Addendum 2
to
COIC Request for Quotes CET 21-14
High Floor Dial A Ride Buses

January 7, 2022

To: ALL REGISTERED VENDORS AND TO WHOM IT MAY CONCERN
From: Drew Orr, COIC Single Point of Contact
RE: ADDENDUM 2

CAMERA LAYOUT
(COVERAGE AND ANGLE)

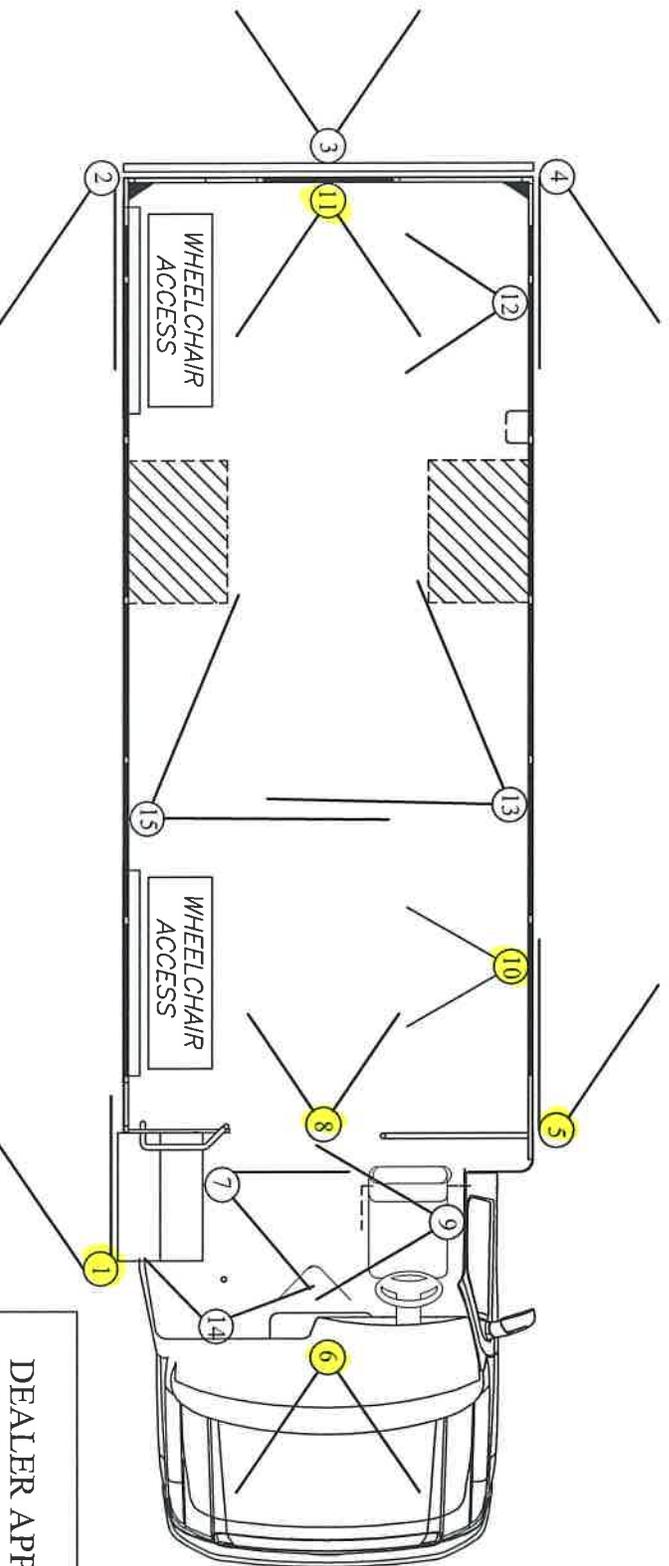
4	Our parts department is requesting camera locations to properly quote. Will you please mark on the attached proposed floorplan where you would like each camera to be located and note if the camera is interior or exterior.	Please see the attached illustration of where COIC would like for the cameras to be located. #1 and #5 are exterior. #6, 8, 10 and 11 are interior.
5	I would like to clarify the requested seating arrangement for this RFQ. In reviewing your request for seating of 12 passengers +3 wheelchairs or 18 passengers total, I am finding that seat spacing is less than ideal. I have attached two sample floorplans, 1 showing 12 rigid and 3 double foldaways and the other showing 10 rigid and 4 double foldaways. I will have to have engineering review the first to ensure that floorplan leaves the required seat spacing. Do you have a sample floorplan showing the desired layout? Would you allow the second floorplan with 2 less rigid and 1 extra double fold?	COIC is seeking to purchase a bus that seats 18 passengers with no W/C and 12 passengers with 3 W/C. We do not know the limitations of a manufacturer so we do not have a desired floor plan. We will evaluate all proposals equally.
